ENVIRONMENTAL HEALTH DIVISION PERMIT NO. 7-96-192

PERMIT TO CONSTRUCT AN INDIVIDUAL SEWAGE DISPOSAL SYSTEM

LOCATION: 1653 GORE DRIVE

RE: Individual Sewage Disposal System serving 1653 Gore Drive, Larkspur, CO 80118

TITLE	SITE PLAN LOT 27, SAGE PORT FILING NO. 4 FIRST AMENDMENT DOUGLAS COUNTY, COLORADO
CLIENT	COUNTRYSIDE BUILDERS

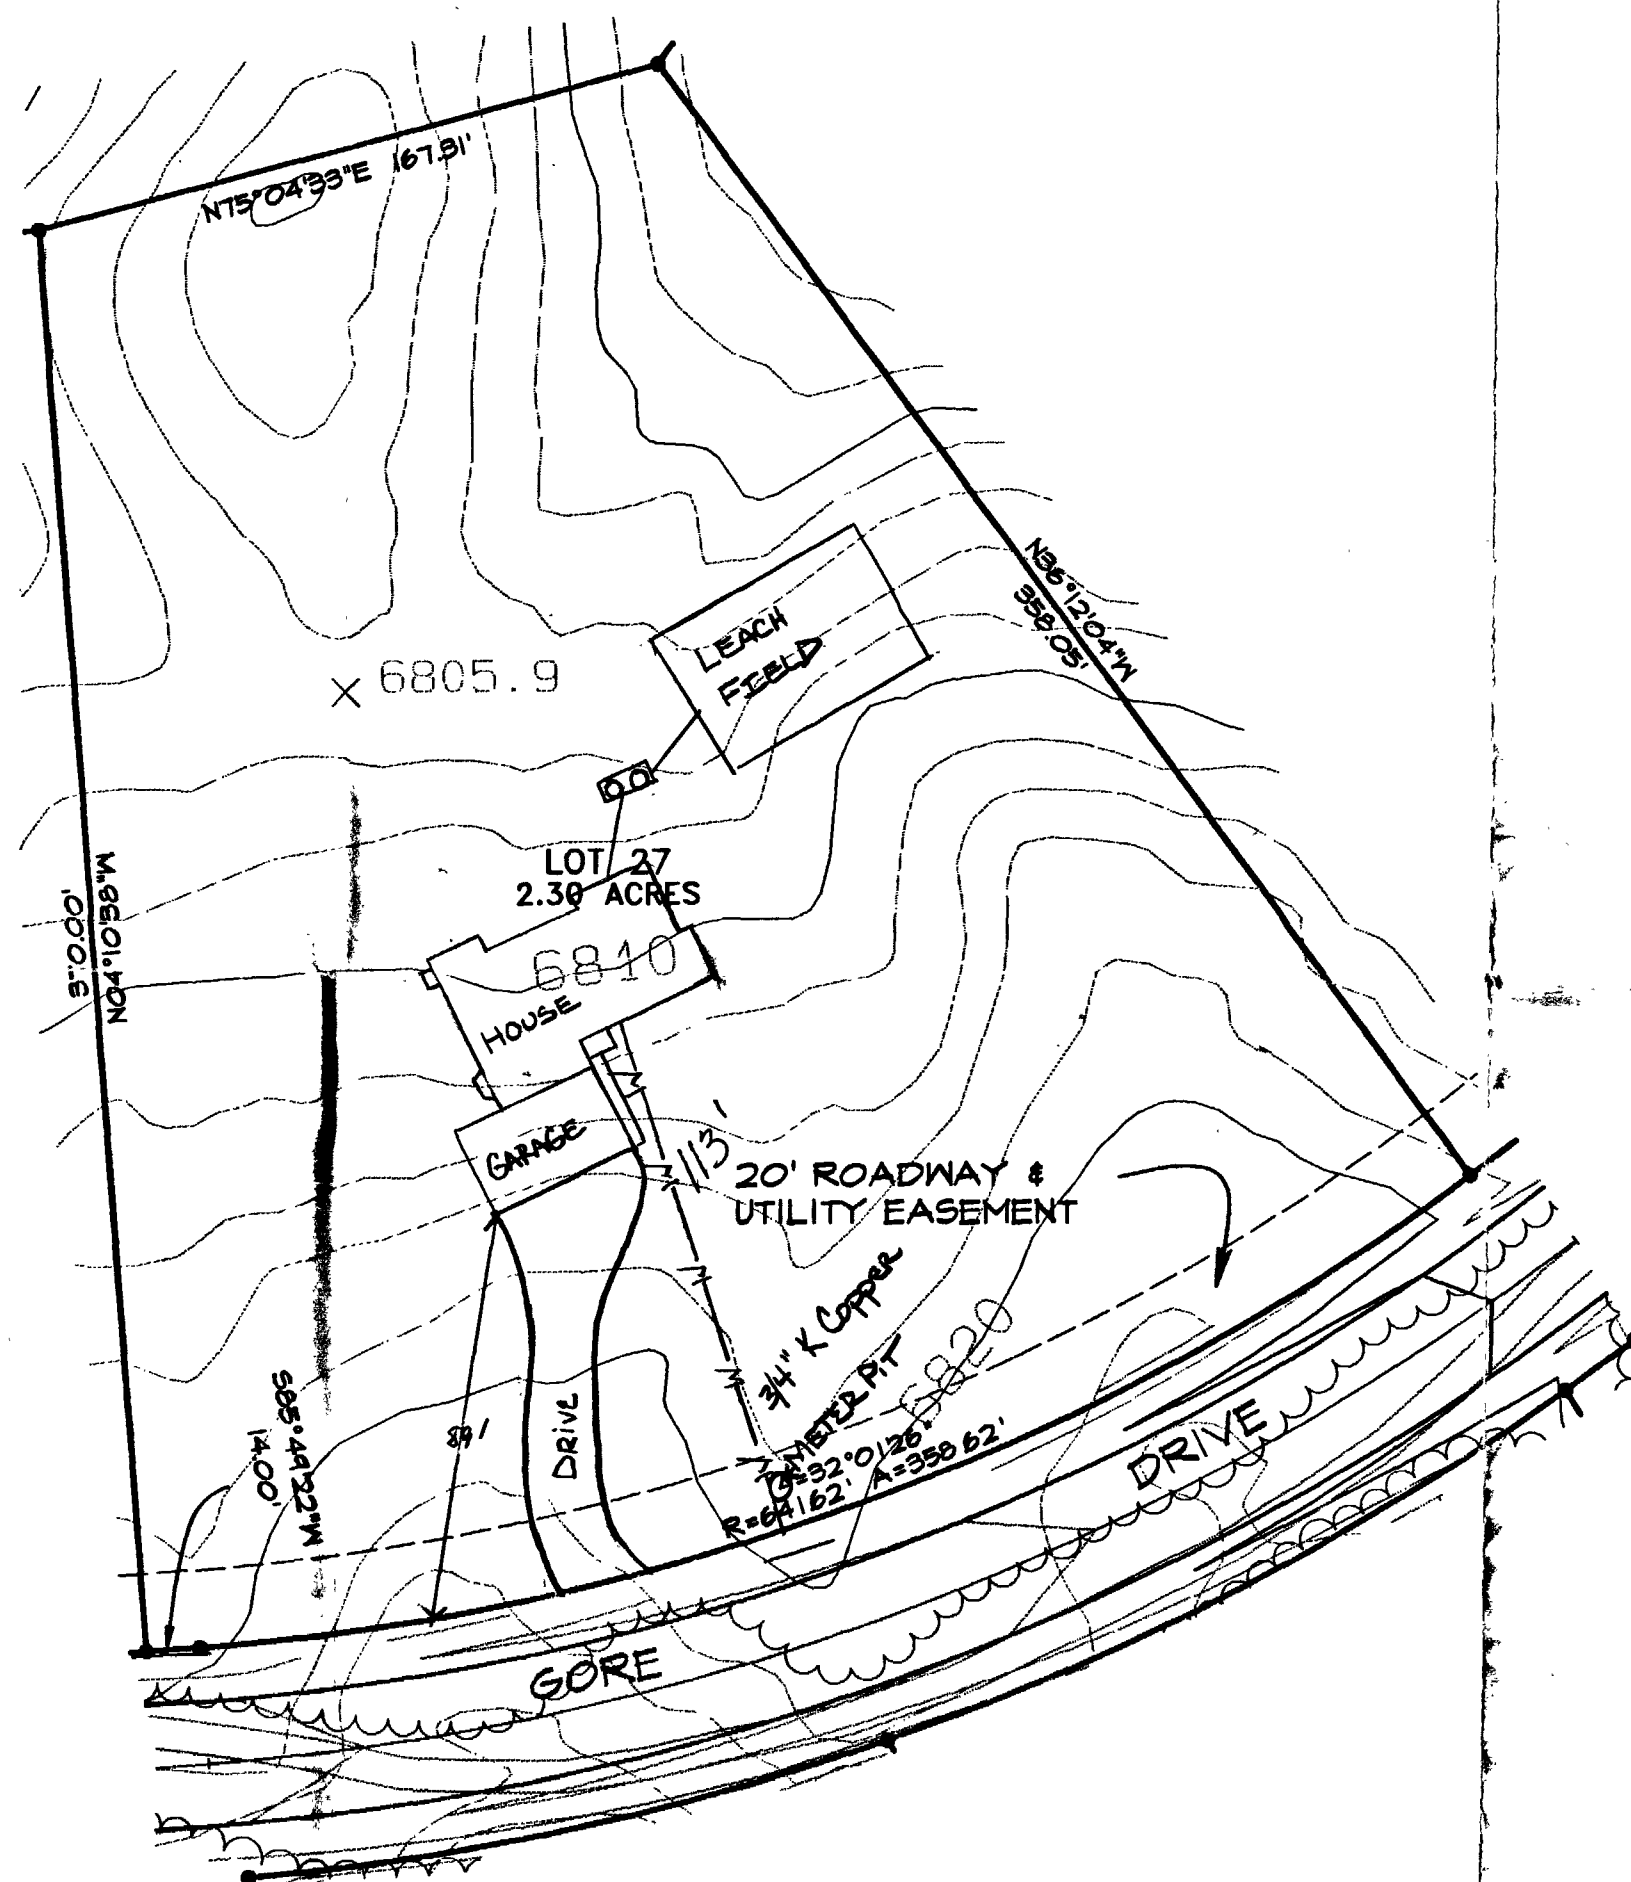
Must install remote
on a 4x4 redwood post
4' above ground.
